ADDENDUM #1

**PROJECT: EMS STATION NO. 9
CITY PARISH PROJECT NO. 21-ASC-CP-1495**

**New EMS Station No. 9
8850 Connell's Village Lane
Baton Rouge, LA 70815**

CITY PARISH PROJECT NO: 21-ASC-CP-1495

Professional Seal
Scale: **As Noted**
Sht Description:
Standards & Signage

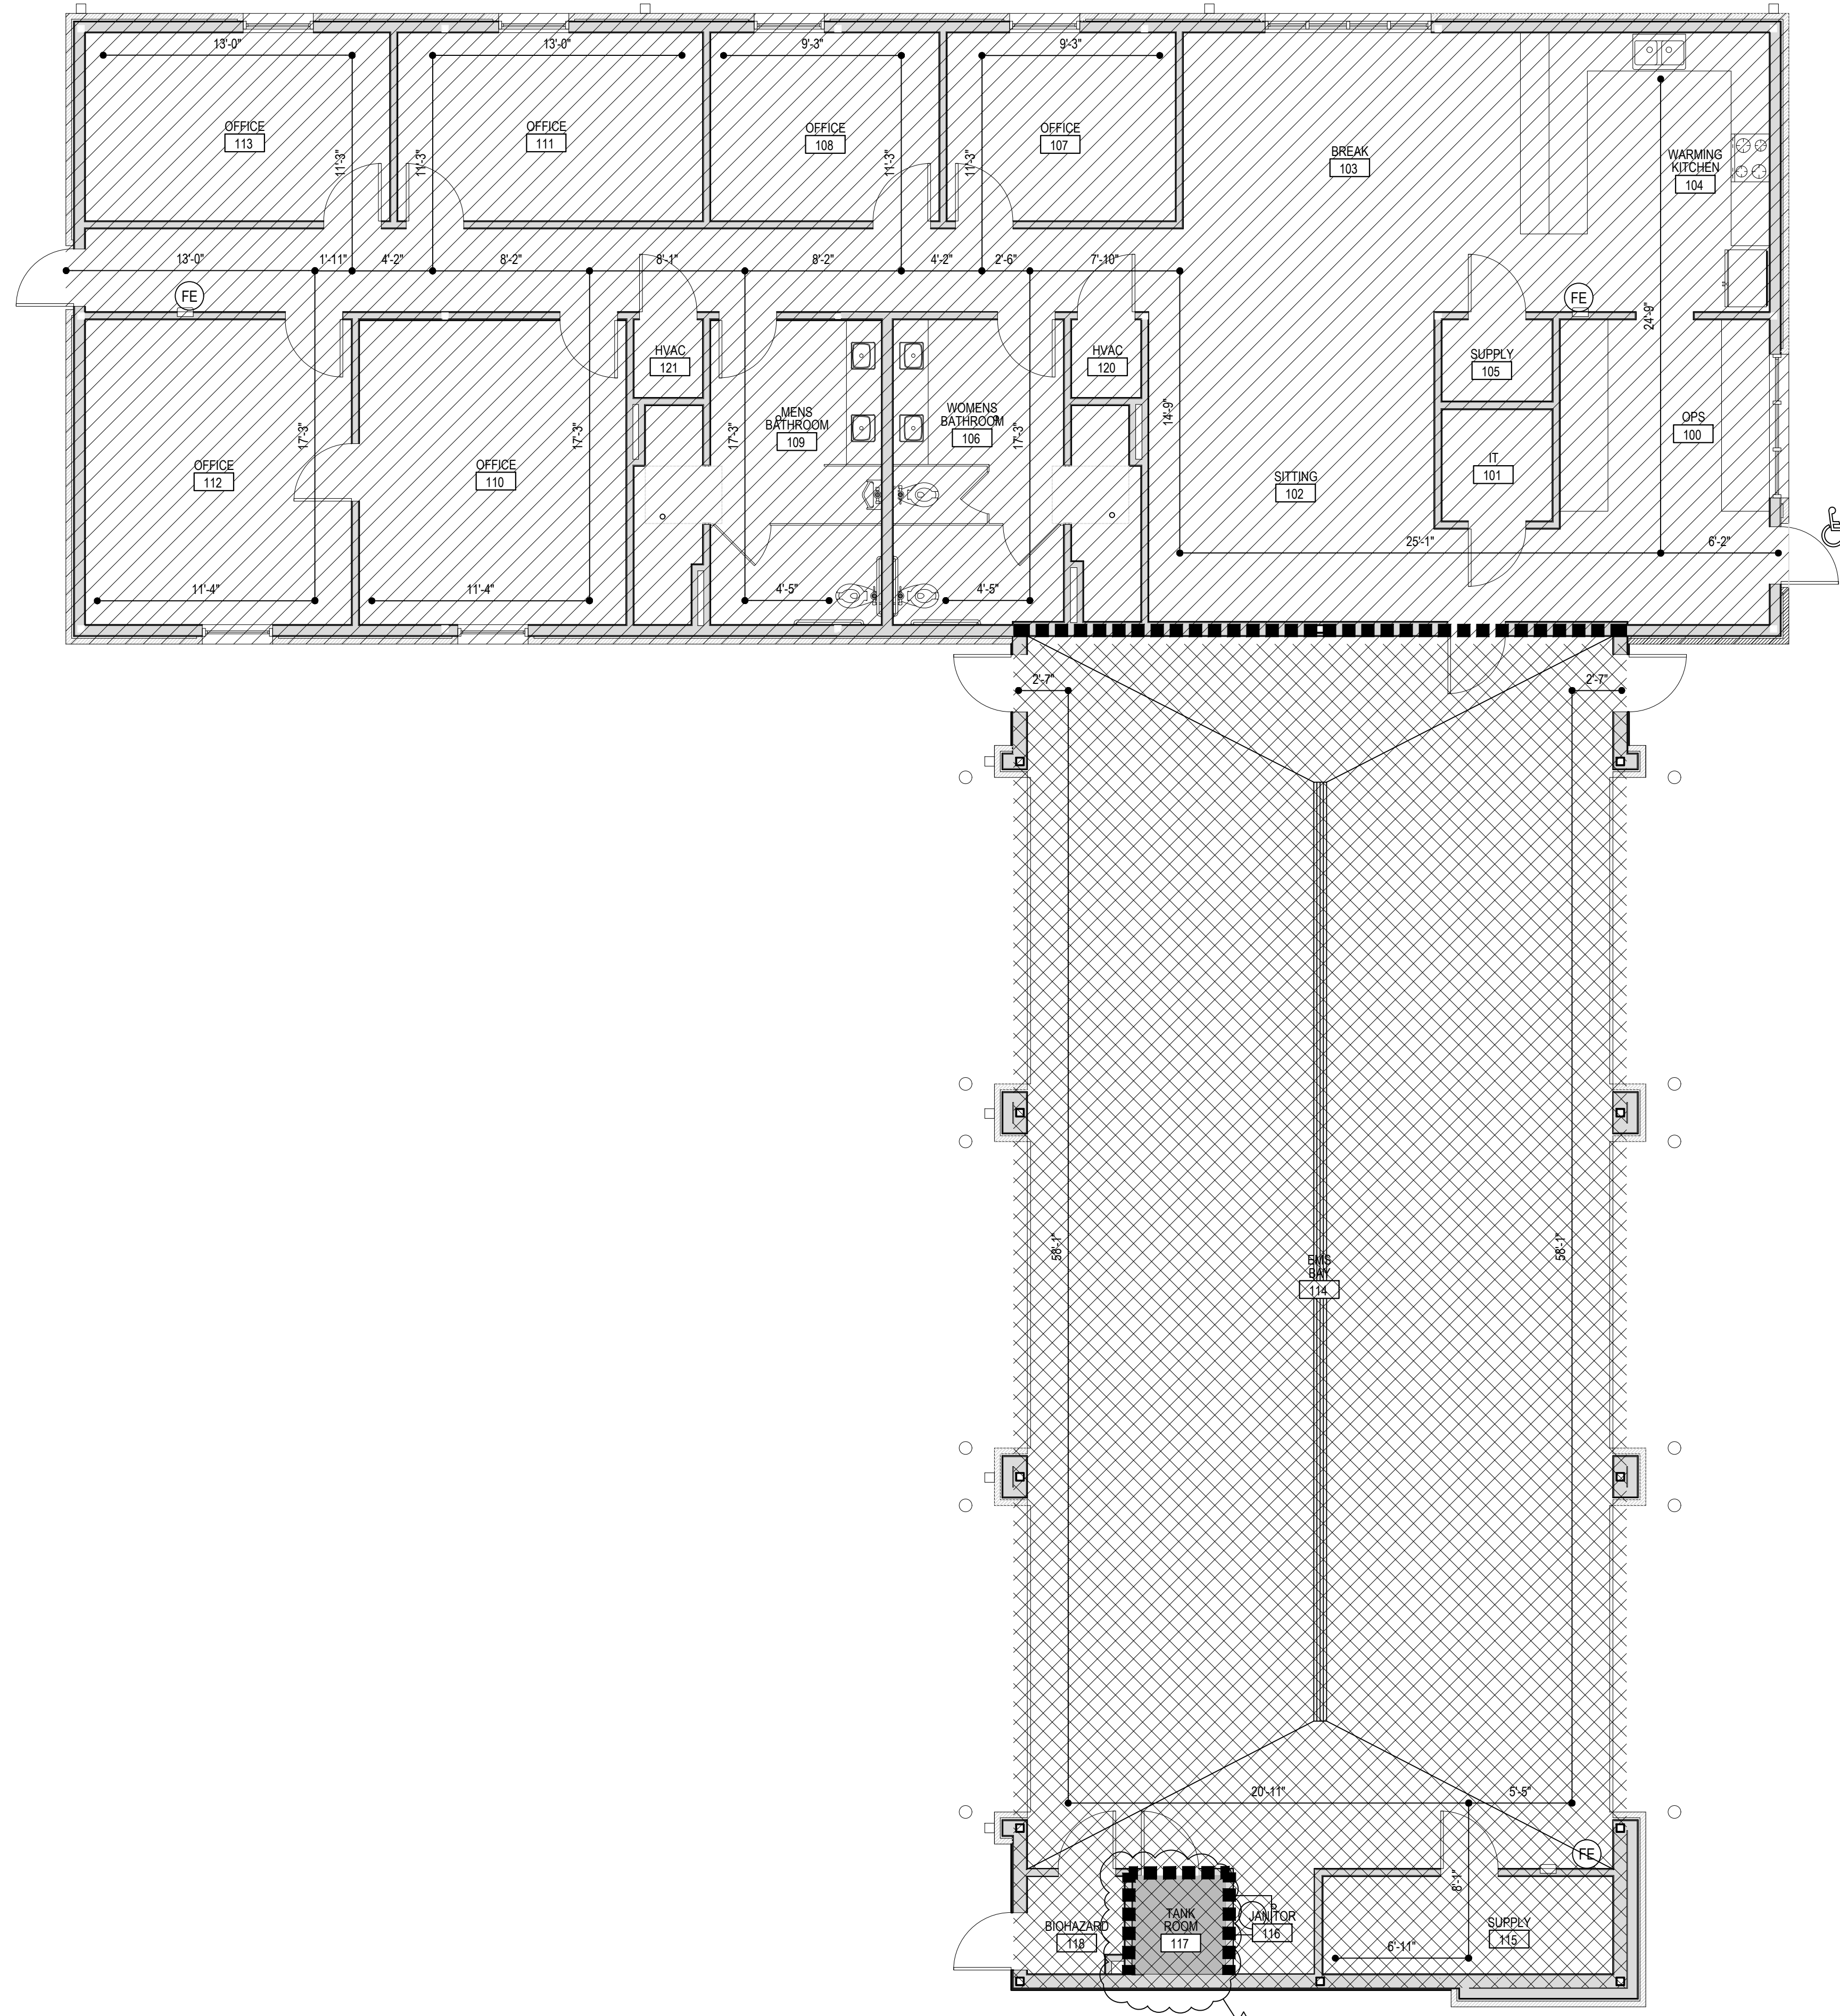
- Sheet G1.01 – General
 - Remove Existing Sheet G1.01 from the bid documents
 - Replace with attached Sheet LS1.01, revisions include, but are not limited to, the following:
 - Added signage for Tank Room 117
- Sheet LS1.01 – Life Safety Plan
 - Remove Existing Sheet LS1.01 from the bid documents
 - Replace with attached Sheet LS1.01, revisions include, but are not limited to, the following:
 - Fire rated enclosure at Tank Room 117
- Sheet A1.01 – Floor Plan
 - Remove Existing Sheet A1.01 from the bid documents
 - Replace with attached Sheet A1.01, revisions include, but are not limited to, the following:
 - Changes to partition types at Tank Room 117
 - Changes to shower orientation and adjacent wall adjustments including clear opening and partition types at Men's Bathroom 109 and Women's Bathroom 106
 - Added partition for duct chase at Biohazard 118
